Subject: Byron Ultimate Heat Sink
 Byron Units 1 and 2,
 NRC Docket Numbers 50-454 and 50-455

Byron/Braidwood UFSAR Change Log

Byron/Braidwood
 UFSAR Change Log
 DRP 4-009

FIGURE 9.2-5

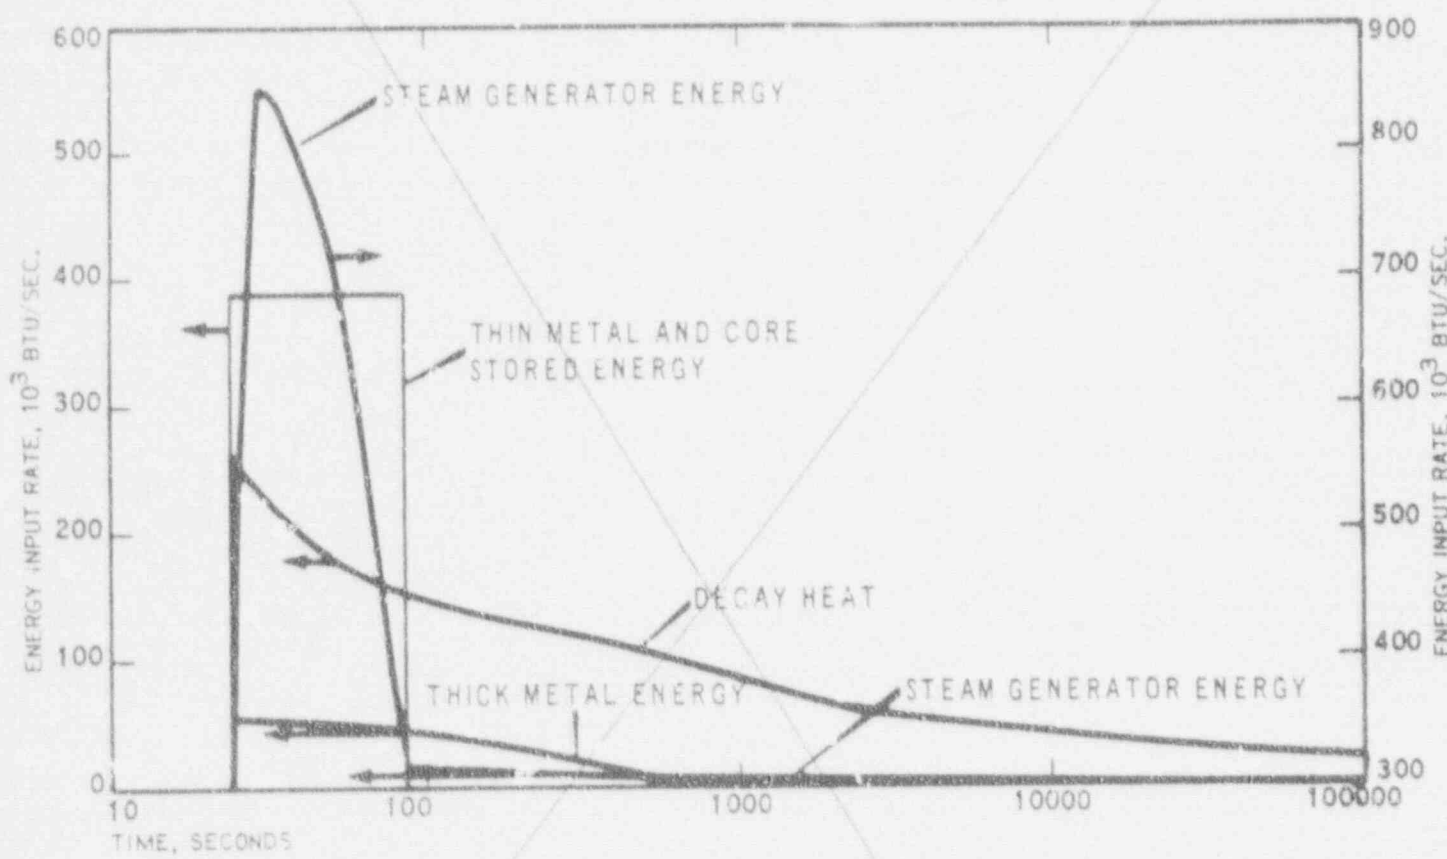
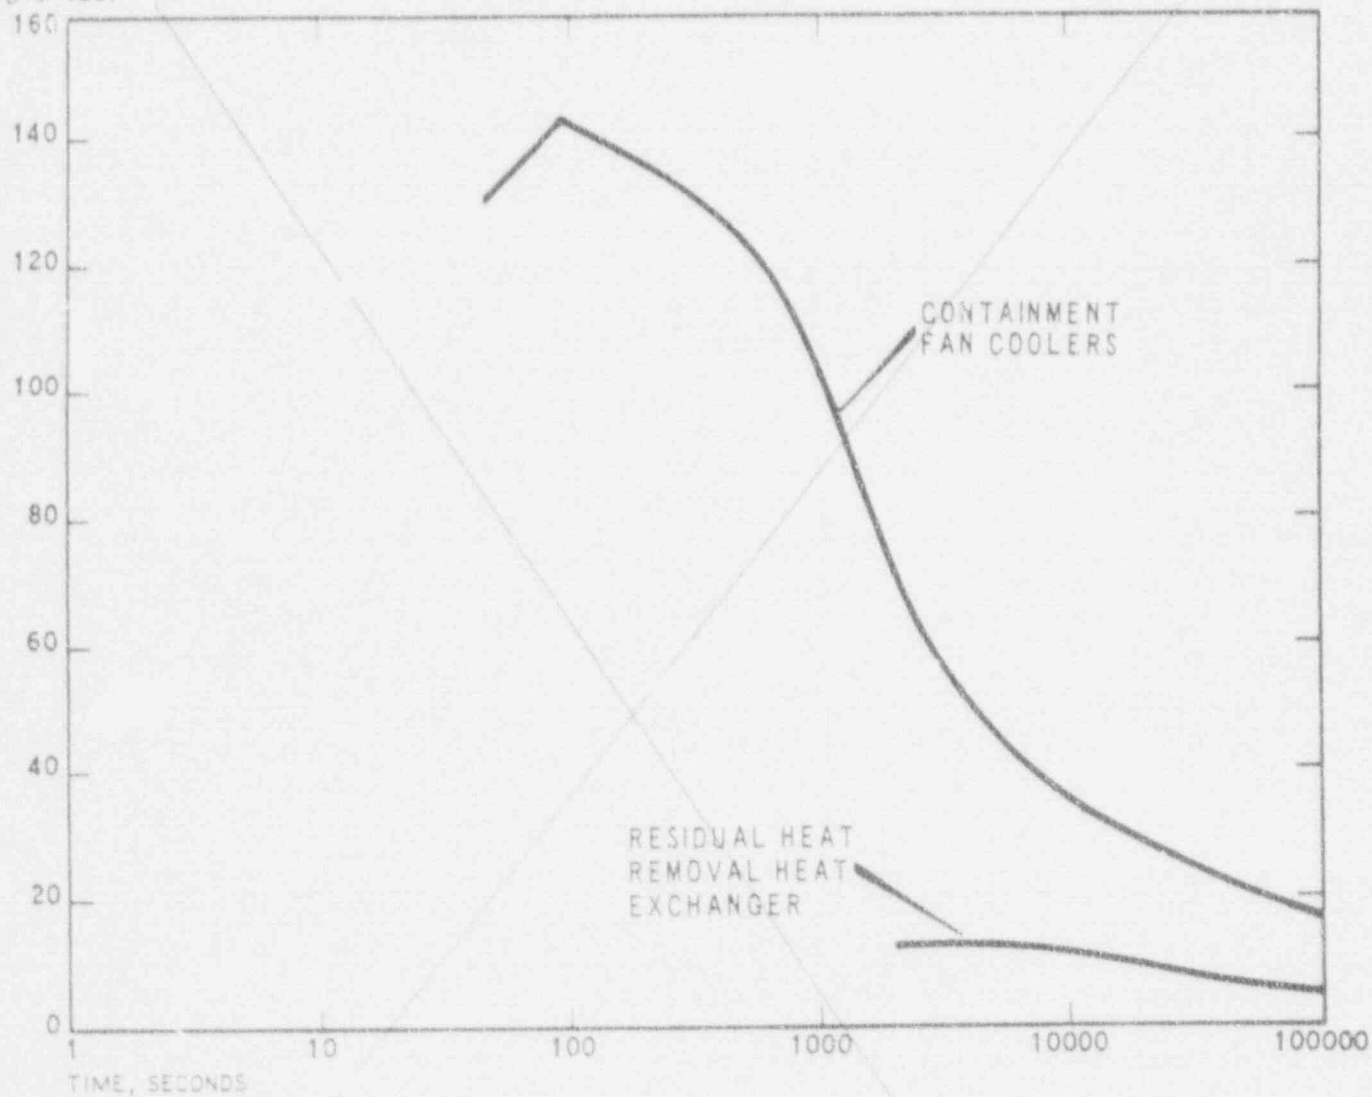
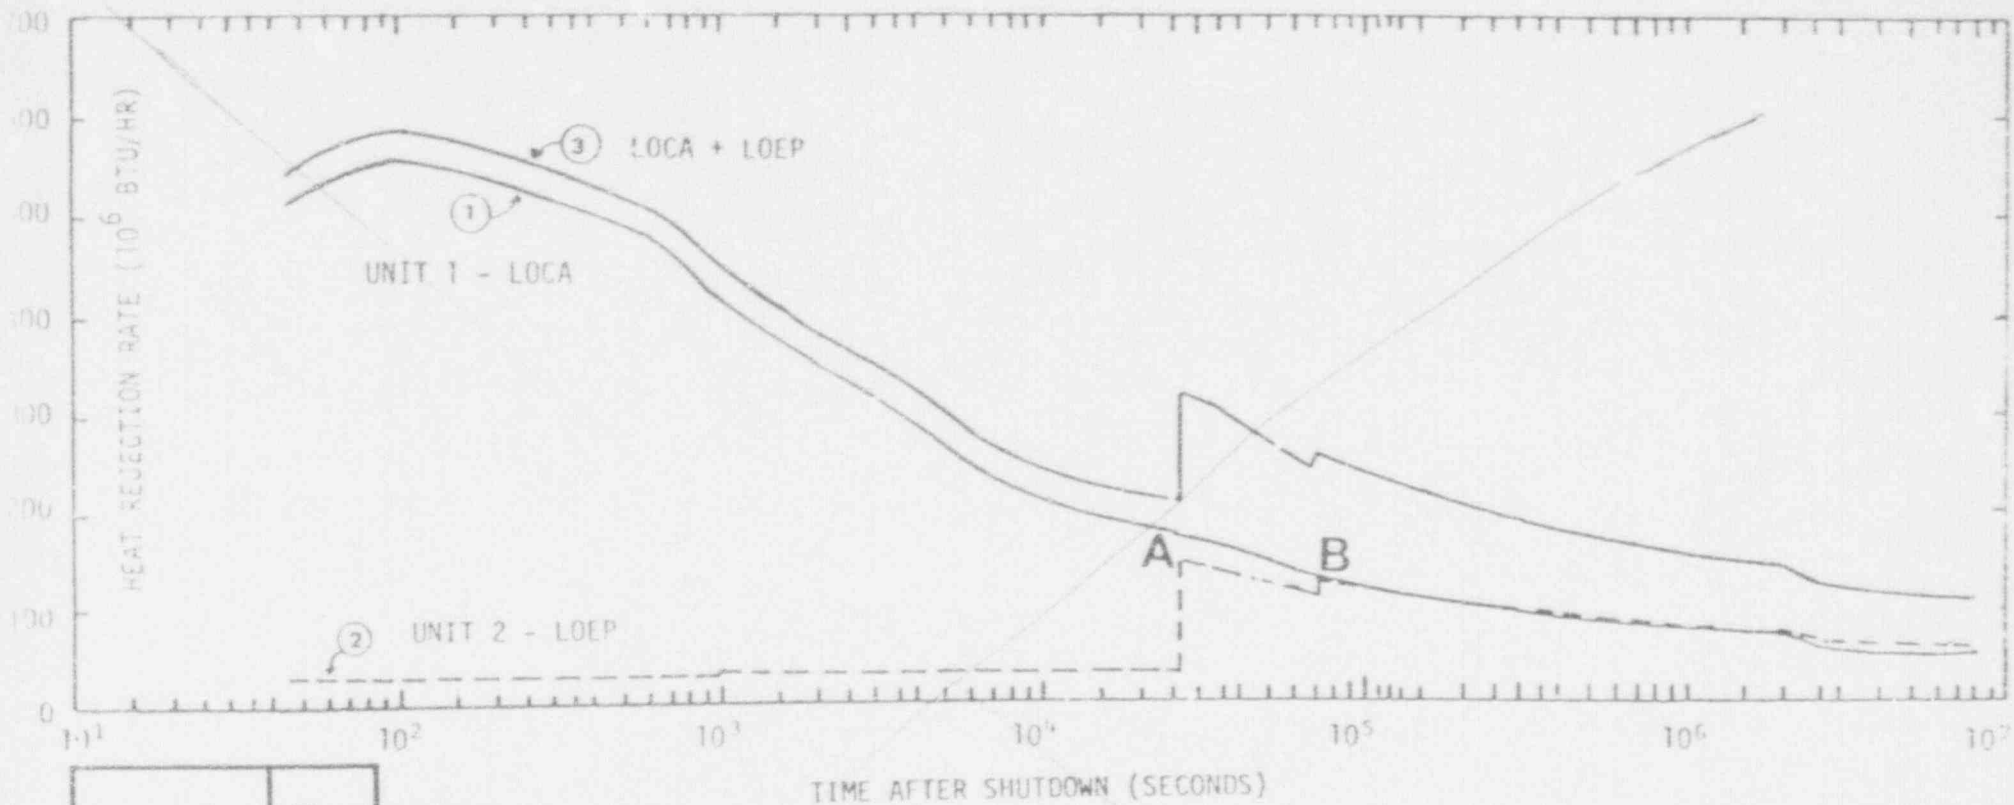
9.2	F9.2-2, Sheet 1	Replace with new figure	Reflect system operation	Normal operating procedure
9.2	F9.2-5	Delete Figure 9.2-5	Obsolete	"Heat Load to the Ultimate Heat Sink during a Loss of Coolant Accident," S&L Calculation ATU-0063, Revision 1, April 1, 1992

9.2	F9.2-6	Delete Figure 9.2-6	Obsolete	Calculation ATU-0063, Revision 1, dated April 1, 1992

FIGURES 9.2-5 AND 9.2-6 HAVE BEEN
INTENTIONALLY DELETED

FIGURE 9.2-7
HEAT REJECTION TO THE ULTIMATE HEAT SINK
FOR TWO 3411 MWT (GUARANTEED CORE
THERMAL POWER) PWR REACTORS
BROUGHT TO COLD SHUTDOWN

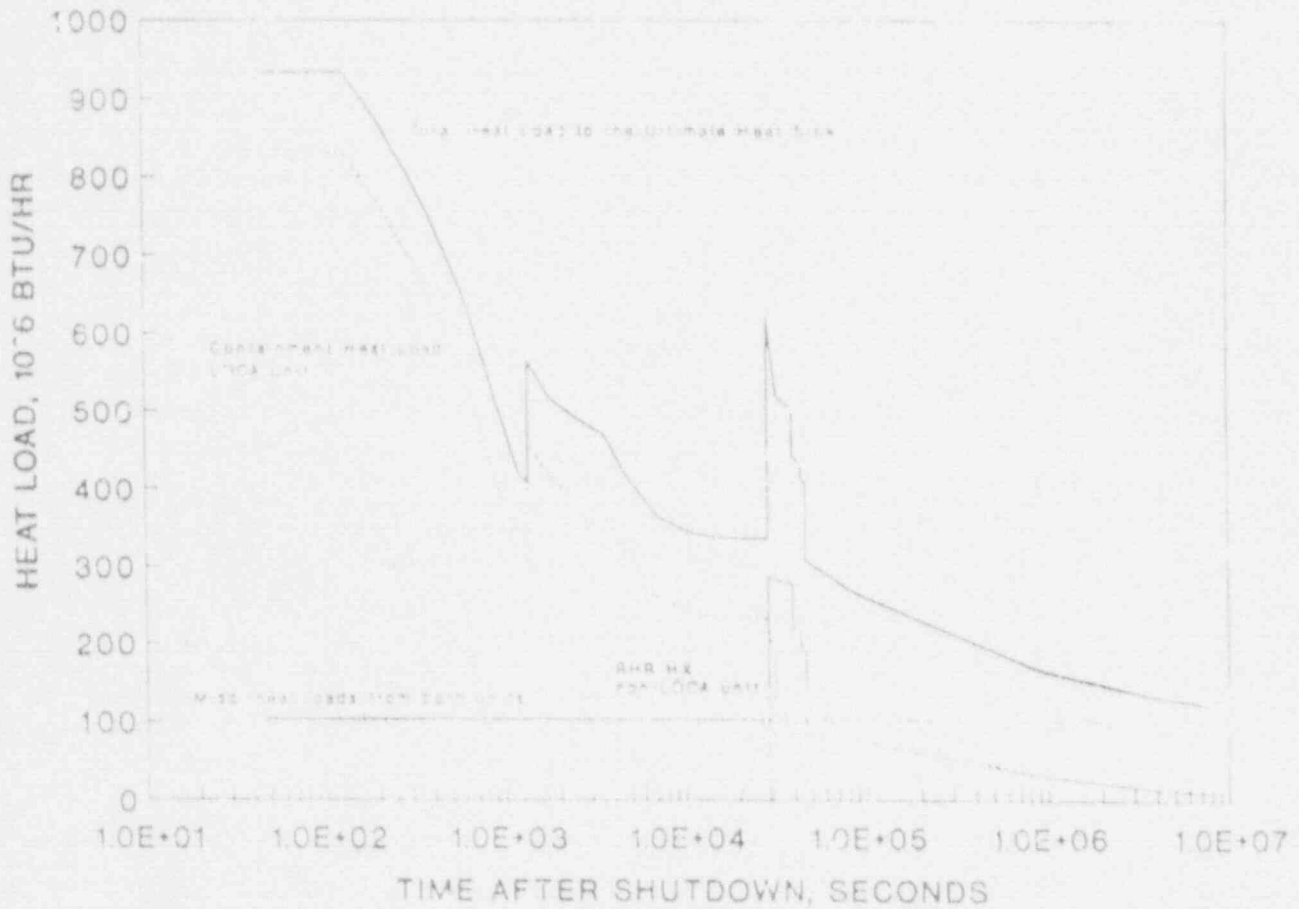
Section	Page	Description of Change	Reason/Basis	References/Remarks
9.2	F9.2-7	Revise Figure 9.2-7	Document calculation results	Calculation ATD-0063, Revision 1, dated April 1, 1992
9.2	F9.2-8 to F9.2-14	Change Figures 9.2-8 through 9.2-14 to 'Braidwood Only'	Editorial	Byron does not have a cooling pond
9.2	F9.2-9 to F9.2-14	Replace Figures 9.2-9 through 9.2-14	Document calculation results	"Thermal Performance of the Ultimate Heat Sink During a Loss of Coolant Accident," S&L Calculation ATD-0109, Revision 1, April 27, 1992
9.2	F9.2-30	Add Figure 9.2-30	Document calculation results	Calculation RSA-B-91-03, Figure 14
9.2	F9.2-31	Add Figure 9.2-31	Document calculation results	Calculation RSA-B-91-03, Figure 15

Replace with a new figure
